Mobile Intel[®] Pentium[®] II Processor Specification Update

Release Date: July 2001

Order Number: 243887-032

The Mobile Pentium[®] II processor may contain design defects or errors known as errata which may cause the product to deviate from published specifications. Current characterized errata are documented in this Specification Update.

New Mobile Pentium® II Processor in Mini-Cartridge Package Label with Supplier Matrix Mark Removed

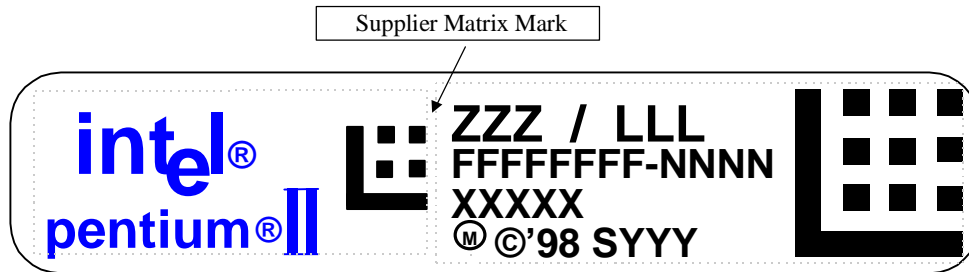
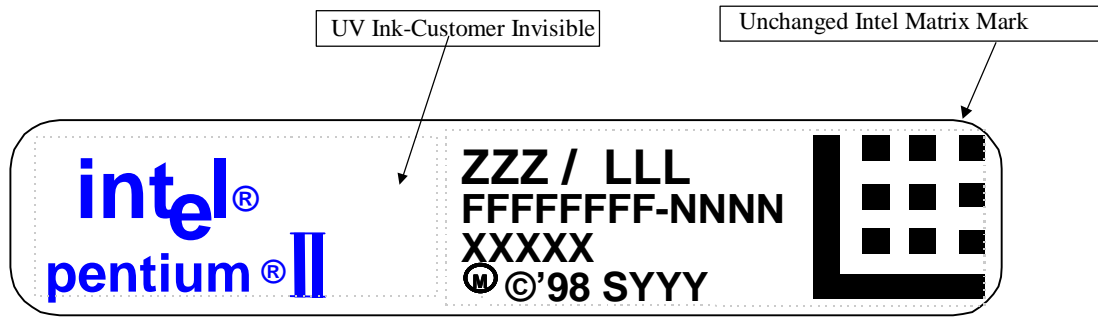
Old Mobile Pentium® II Processor in Mini-Cartridge Package Label with Supplier Matrix Mark

Figure 2. Workaround Flowchart: SMBALERT#-Driven System

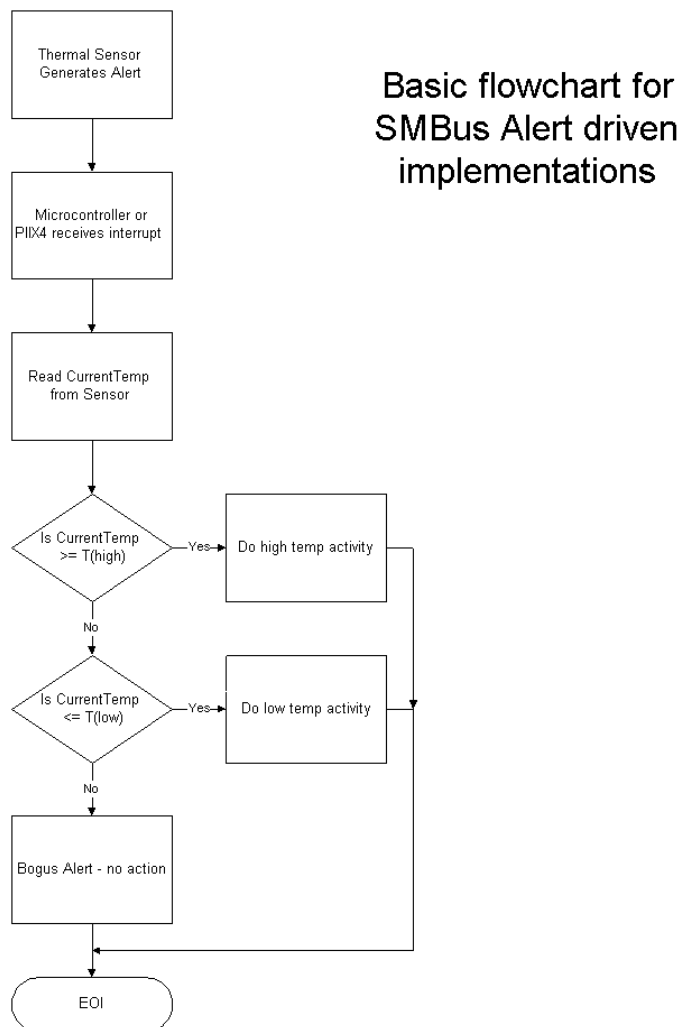
1. Before servicing an interrupt from the thermal sensor, read and compare the processor thermal reading with the threshold limits (T_{HIGH} or T_{LOW}). Figures 2 and 3 provide basic flowcharts for the implementation of this workaround in an interrupt driven system.
2. If the firmware implemented polls the Status Register only, then before taking any action, re-read the temperature register and do a comparison with the alarm threshold limits (T_{HIGH} or T_{LOW}) to determine if the value is actually still within the temperature window.

3. Use a temperature polling scheme to monitor the processor temperature.

Figure 5.6. Cross Sectional View with Vertical Dimensions

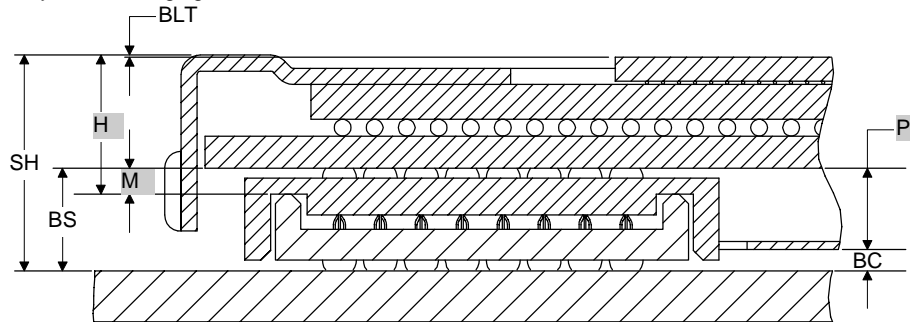
B1. Misabeled Vertical Dimension Parameters

Figure 5.6 in the *Mobile Pentium® II Processor at 233 MHz, 266 MHz, and 300 MHz* datasheet should be replaced by the following figure:

Figure 5.3. Surface-Mount BGA1 Package—Top and Side View

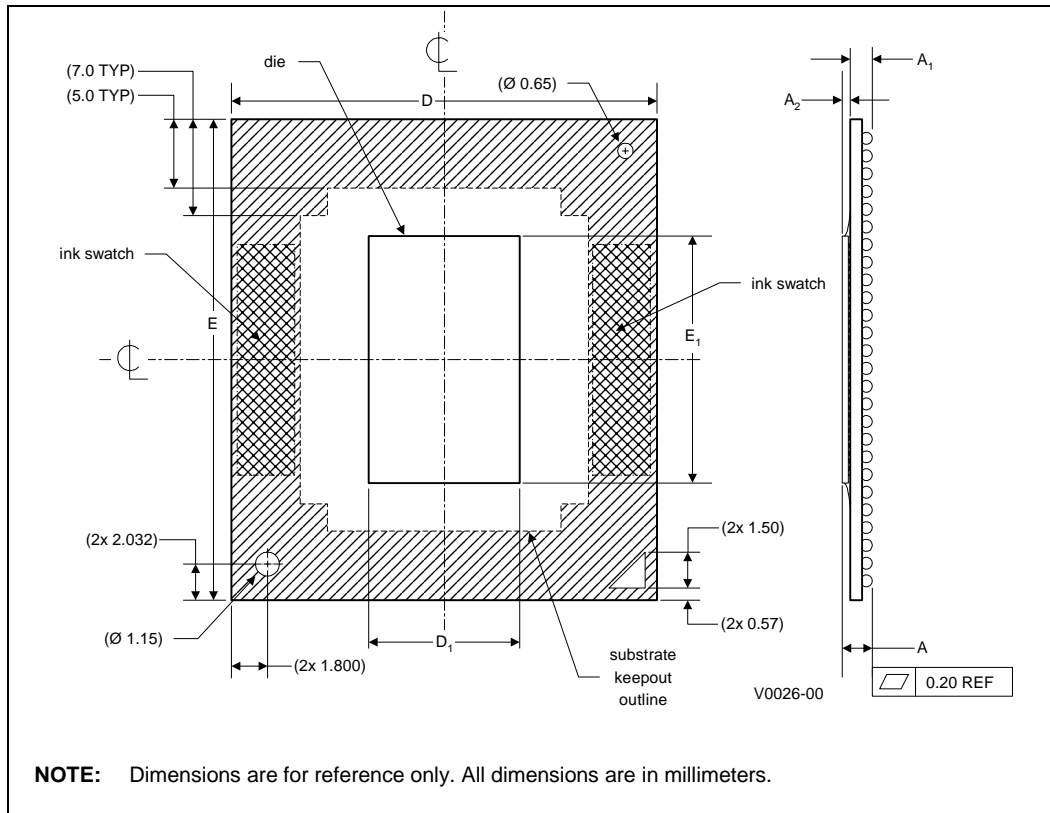
The following table and figures show the updated mechanical specifications for the BGA1 package, listed as Table 5.2, Figure 5.3 and Figure 5.4, respectively, in the *Mobile Pentium® II Processor in BGA Package at 366 MHz, 333 MHz, 300PE MHz, and 266PE MHz* datasheet.

Figure 3.3 Generic Clock Waveform

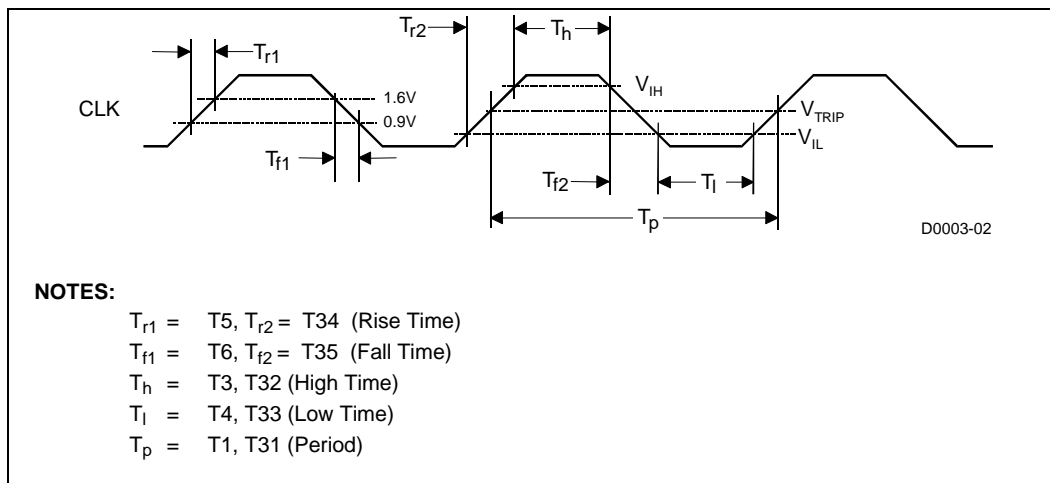
B14. Generic Clock Waveform Figure

Figure 3.3 in *Mobile Pentium® II Processor in Mini-Cartridge Package at 366 MHz, 333 MHz, 300PE MHz, and 266PE MHz* datasheet (Order Number 245108), and the *Mobile Pentium® II Processor in BGA Package at 366 MHz, 333 MHz, 300PE MHz, and 266PE MHz* datasheet (Order Number 245106) has been updated. The following figure is to replace the ones in the above documents.

Figure 1. TAP Gageable Thread Clarification

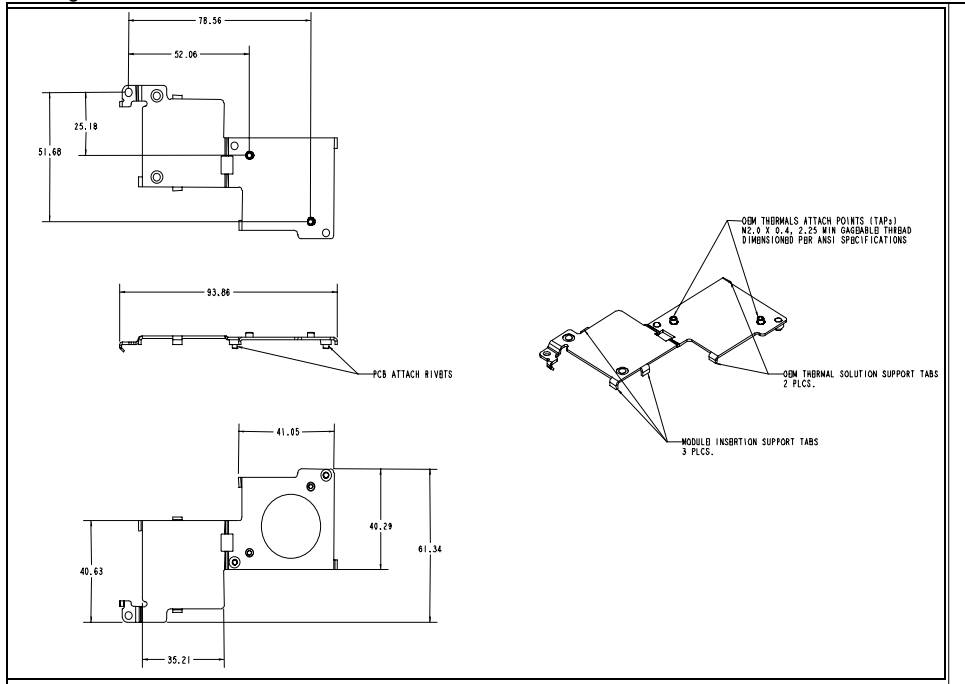
In the *Intel® Pentium® II Processor Mobile Module : Mobile Module Connector 1 (MMC-1)* and the *Intel® Pentium® II Processor Mobile Module : Mobile Module Connector 2 (MMC-2)* datasheets (Order Numbers 243667 and 243668, respectively), the thermal attach point (TAP) gageable thread specification was not clearly identified in Figure 14, of Section 5.2. The following is the TAP clarification:

OEM Thermal Attach Points (TAPs) M2.0 x 0.4, 2.25 min gageable thread dimensioned per ANSI specification.

See Figure 1 below for more information.
